ADDENDUM #3

GADSDEN CITY HALL

Gadsden, AL WBA #23-083.00

DATE: 13 December 2024

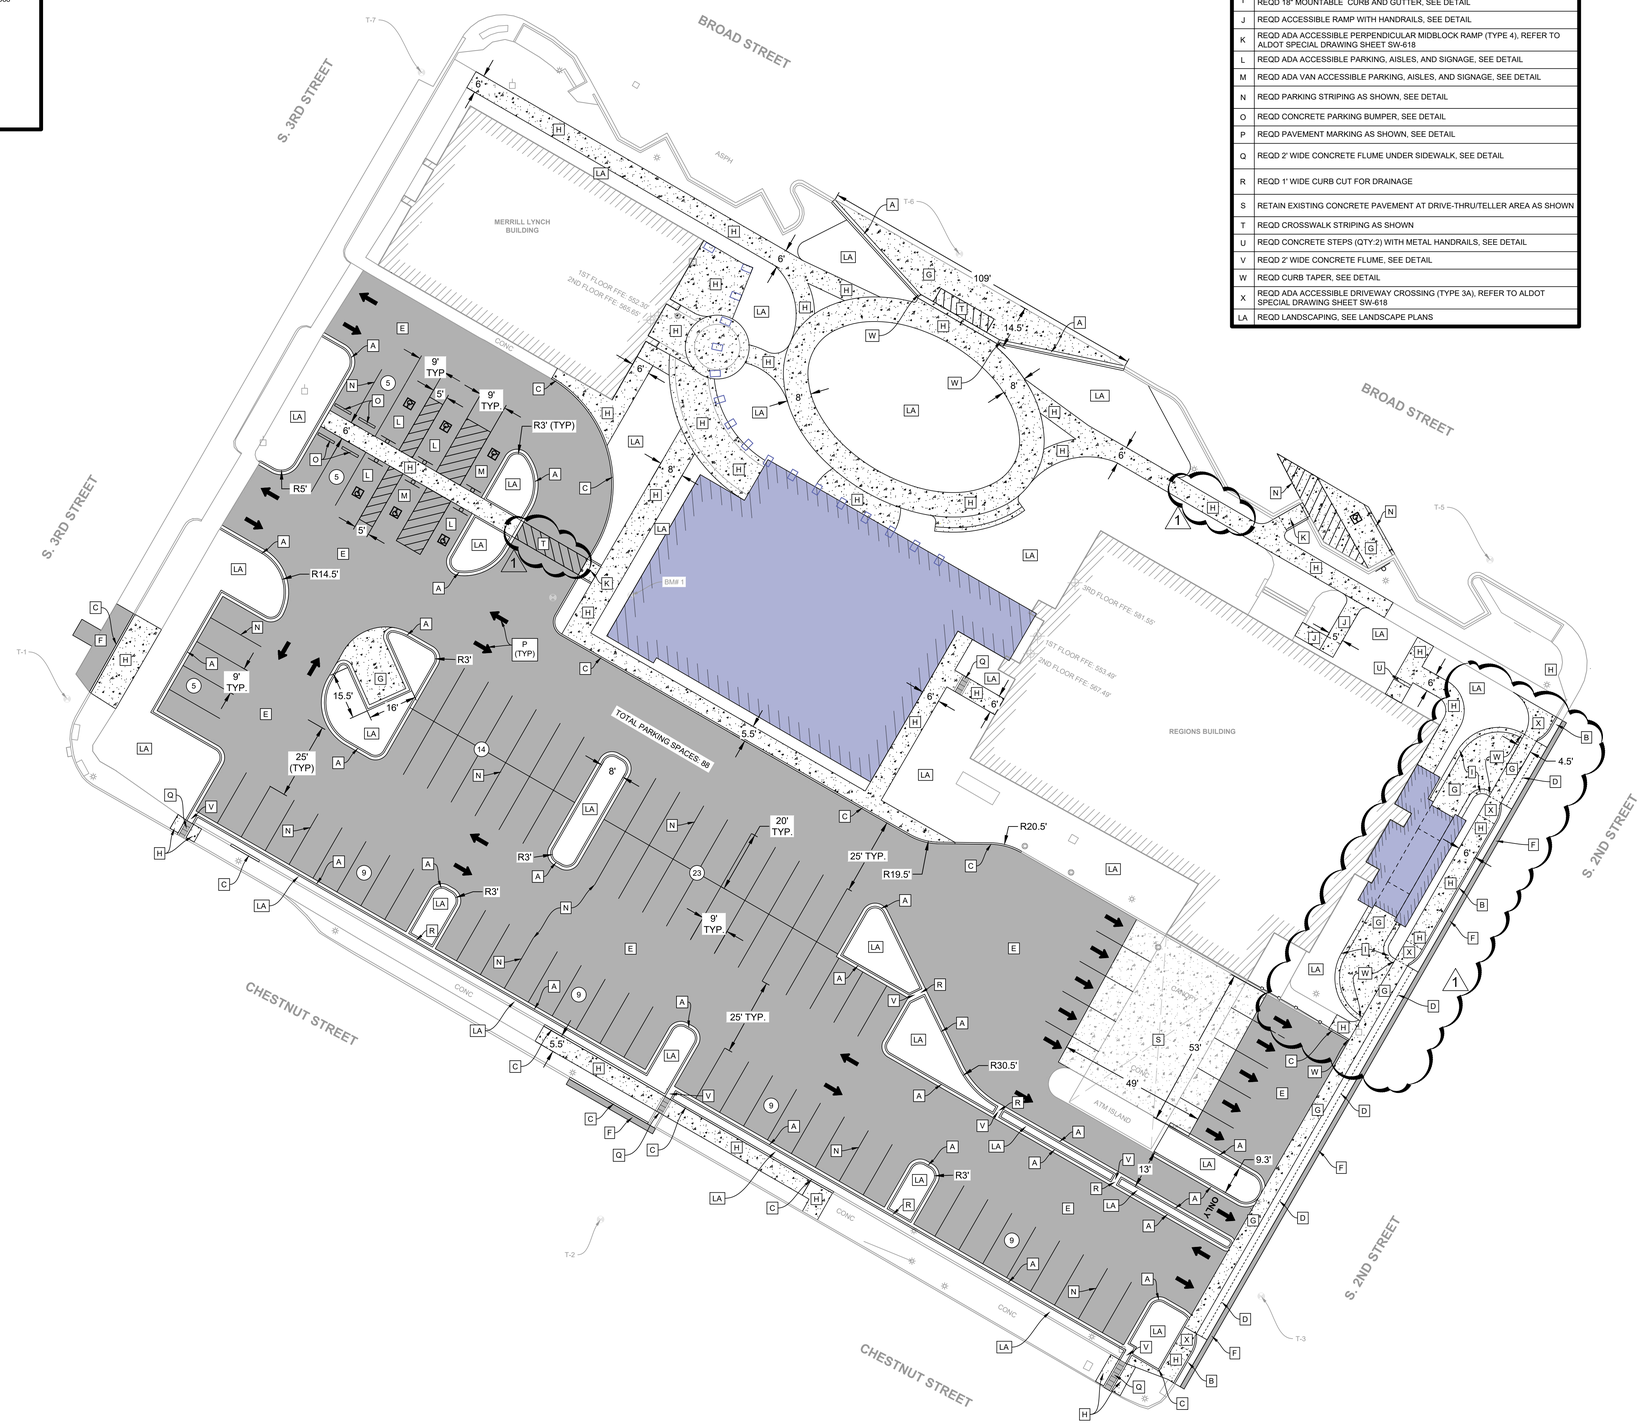
1. **Sheet C-102 – Site Demolition Plan:**
   a. Replace this sheet in its entirety. See attachments.
   b. Adjusted limits of civil demolition to reflect design revisions per C-301.
   c. Adjusted callouts and tags as needed.

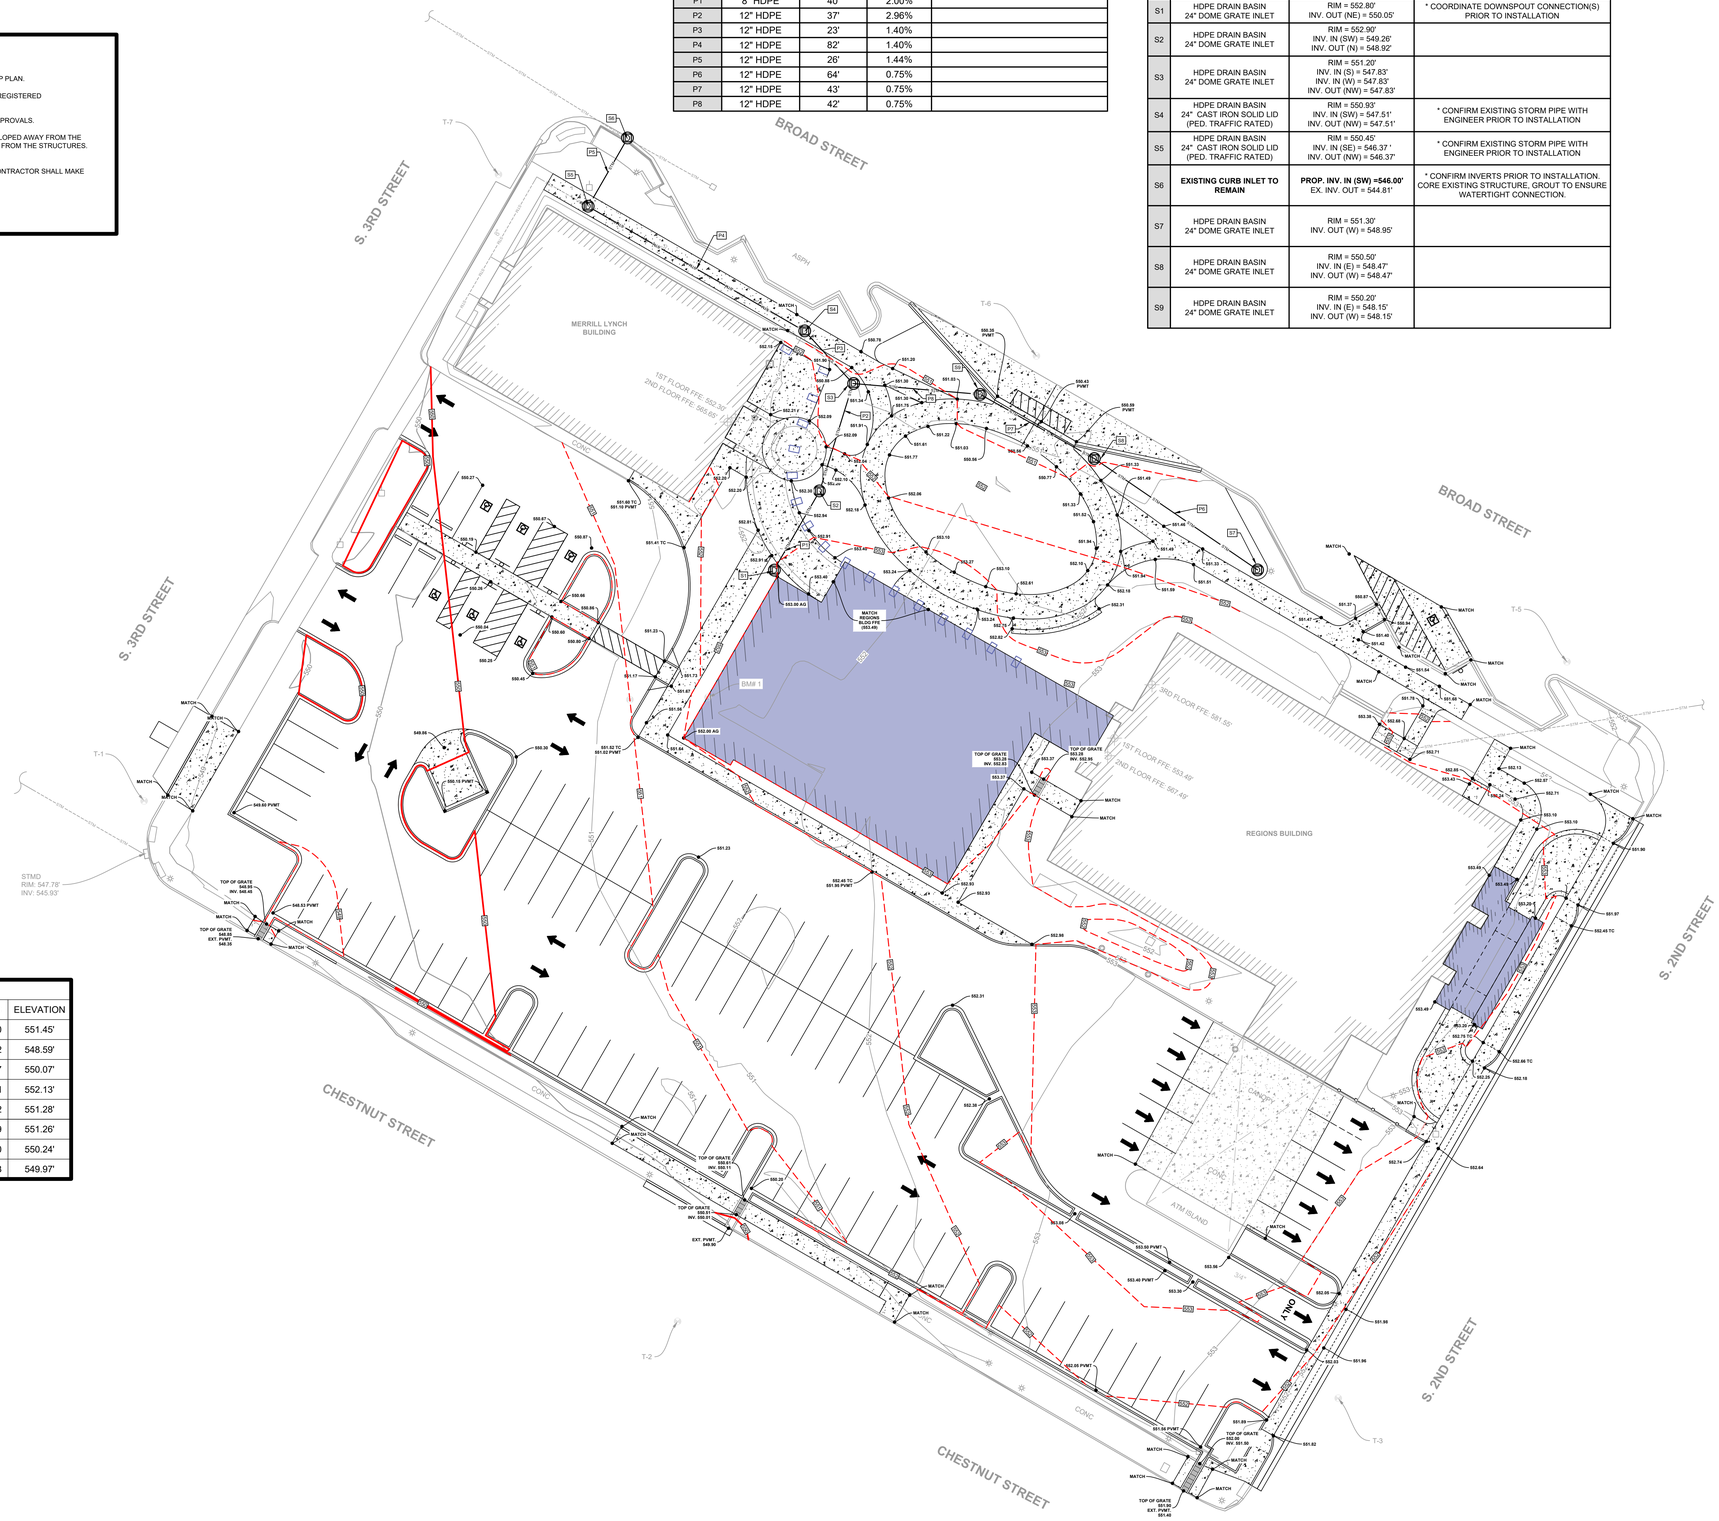
2. **Sheet C-301 – Site Layout Plan:**
   a. Replace this sheet in its entirety. See attachments.
   b. Revised layout of garage access drives to 2nd Street.
   c. Revised layout of northernmost bank teller exit lane to 2nd Street.
   d. Proposed concrete ADA access crossing drive in parking lot changed to asphalt pavement.
   e. Replacement of existing concrete sidewalk section along Broad Street.
   f. Adjusted callouts and tags as needed, including corrections in response to RFI #14.

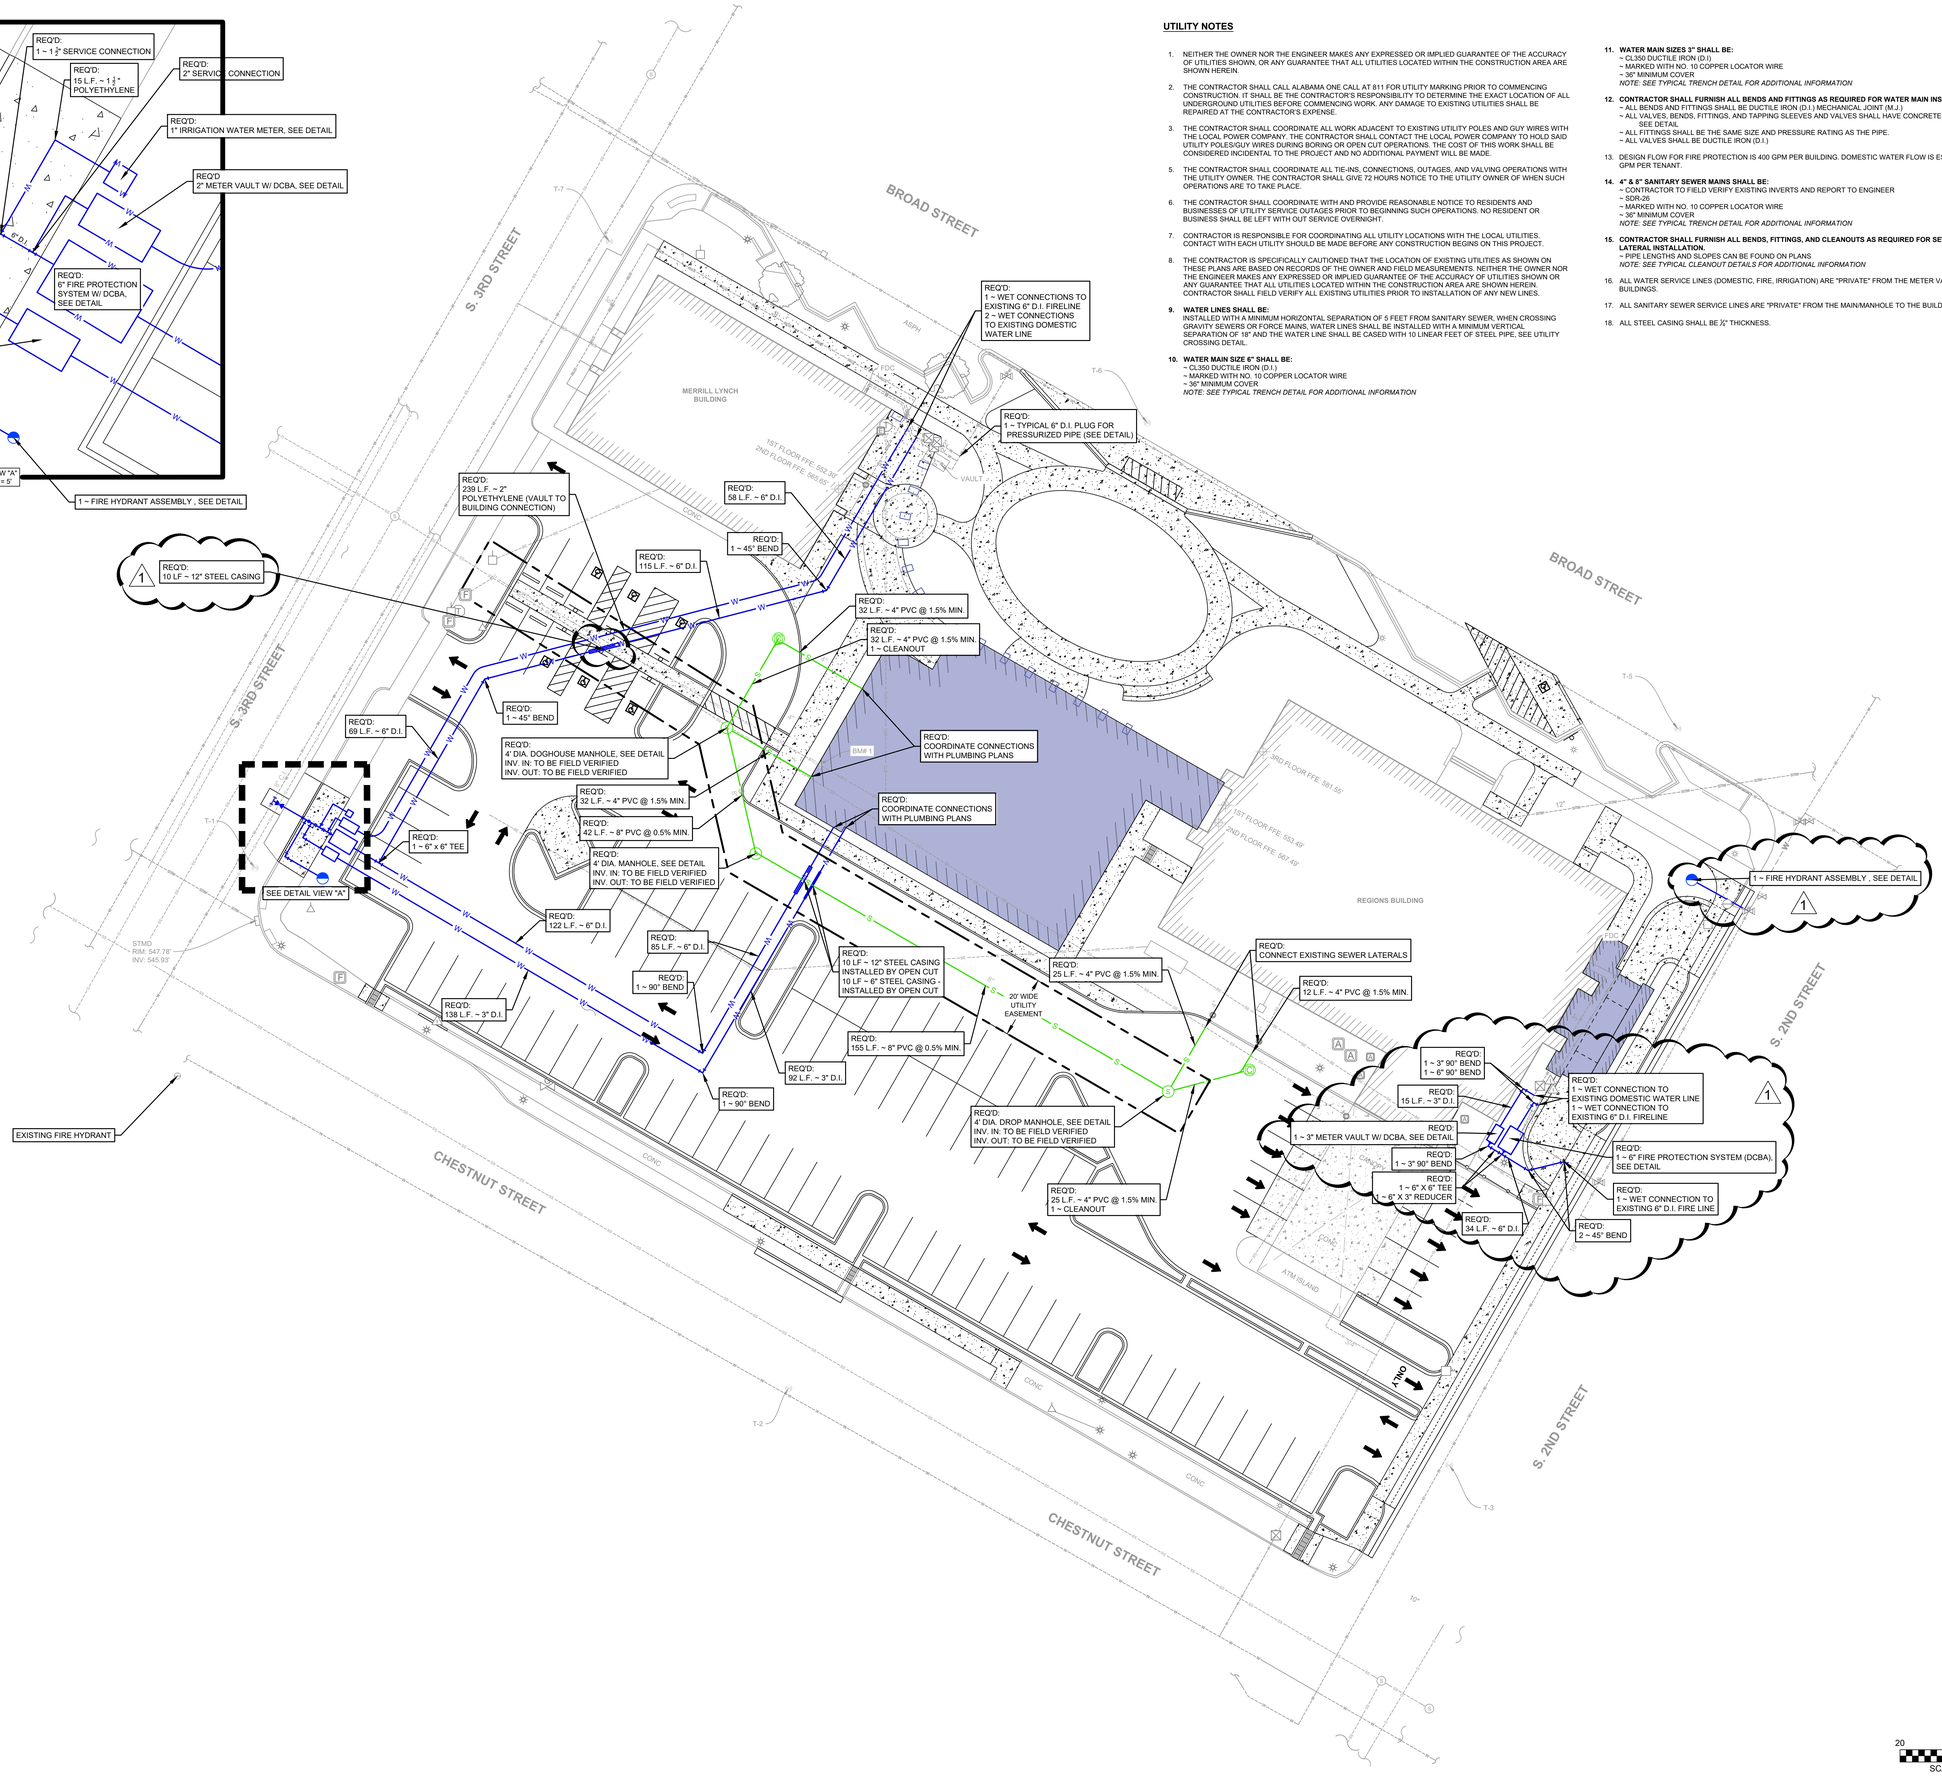
4. **Sheet C-303 – Site Utility Plan:**
   a. Replace this sheet in its entirety. See attachments.
   b. Fire hydrant assembly replaced/relocated along 2nd Street.
   c. Steel casing added to fire line serving Merrill Lynch Building.
   d. Revised vault/meter configuration serving Regions Building.
   e. Adjusted callouts and tags as needed.

2ND FLOOR FRAMING PLAN

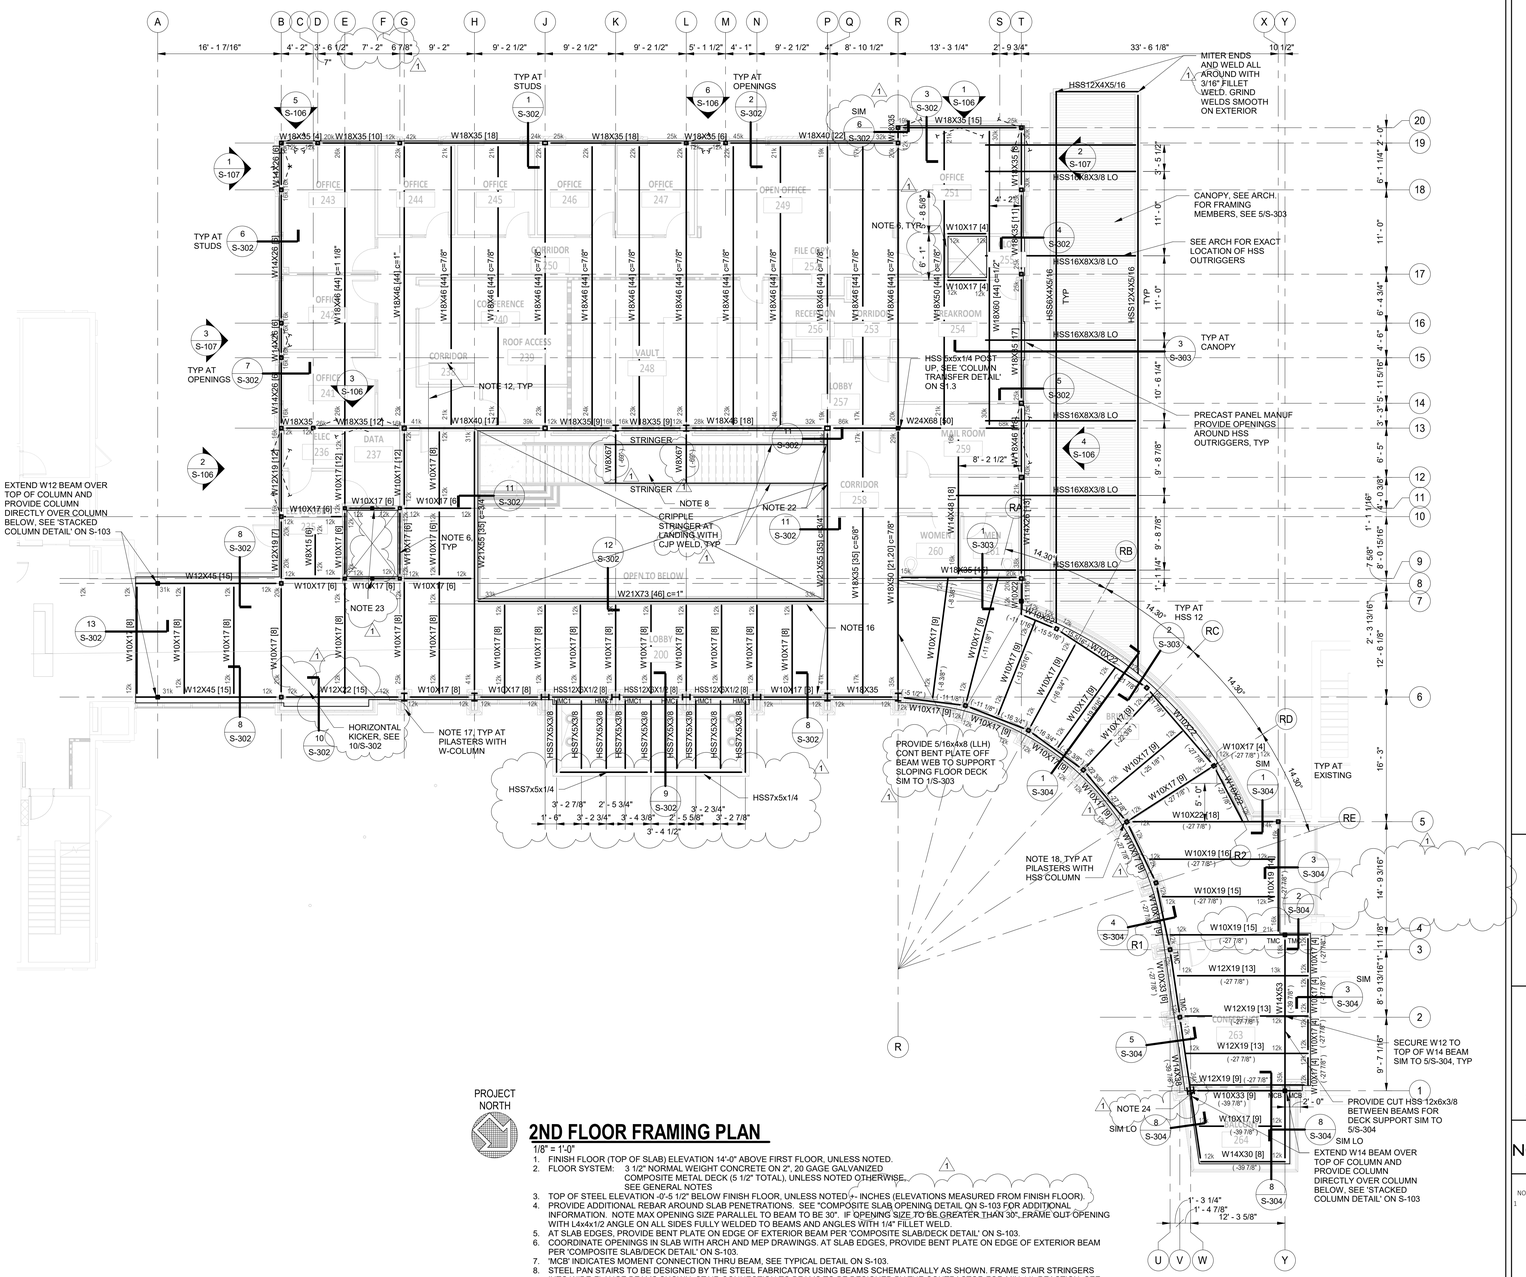
b. Added section 6/S-302 callout.
c. Clarified weld of mitered ends at floating canopy.
d. Changed beam size and framing at plan east walkway.
e. Changed beam framing (plan note 14) at column W1.
f. Added dimensions to beams around mechanical chase opening.
g. Added dimensions to beams at front entrance canopy.
h. Added note for sloping walkway canopy support.
i. Clarified cripple stringer weld at monumental stair.
j. Changed stair outrigger beam size.
k. Added columns for elevator rail support.
l. Show kickers from section 10/S-302.
m. Clarified plan notes 3 and 17.
n. Added plan notes 23 and 24.
o. See attachments.
